The enclosed Traffic Impact Study (TIS) review letter for the proposed **Anchor's Run** (Tax Parcel: 234-6.00-19.00, 20.01) residential development has been completed under the responsible charge of a registered professional engineer whose firm is authorized to work in the State of Delaware. They have found the TIS to conform to DelDOT's Development Coordination Manual and other accepted practices and procedures for such studies. DelDOT accepts this letter and concurs with the recommendations. If you have any questions concerning this letter or the enclosed review letter, please contact me at [Annamaria.Furmato@delaware.gov](mailto:Annamaria.Furmato@delaware.gov).

RE: Agreement No. 1773  
Traffic Impact Study Services  
**Task No. 1A Subtask 6A – Anchor’s Run (fka Insight at Lewes Run)**  
**Updated TIS Review Letter to Reflect 2022 Proposed Development Changes**

McCormick Taylor has completed its review of the Traffic Impact Study (TIS) for the Anchor’s Run residential development (formerly known as Insight at Lewes Run) prepared by The Traffic Group, Inc. dated September 28, 2017. The Traffic Group prepared the report in a manner generally consistent with DelDOT’s *Development

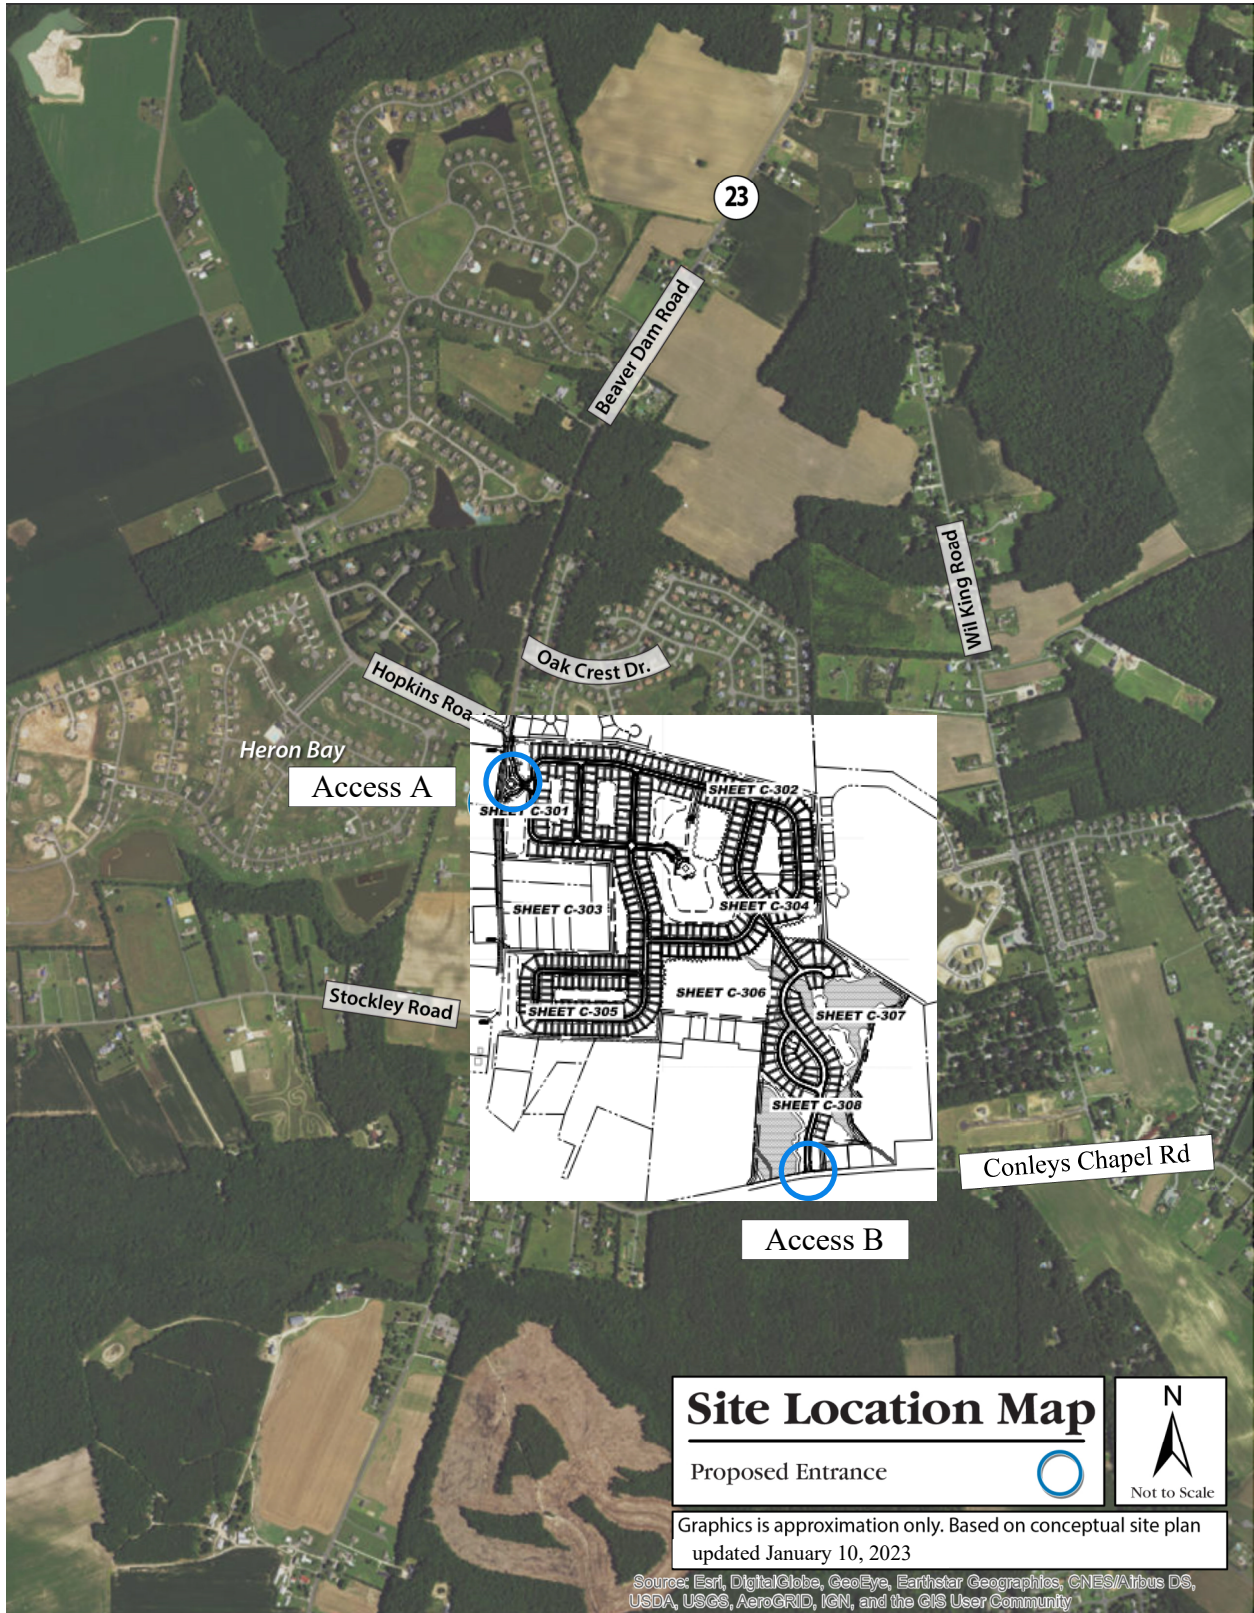
**Location:** The Anchor's Run residential development is proposed to be located on the east side of Delaware Route 23 (Beaver Dam Road / Sussex Road 285), between Hopkins Road (Sussex Road 286) and Stockley Road (Sussex Road 280) in Sussex County, Delaware. A site location map is included on page 11.
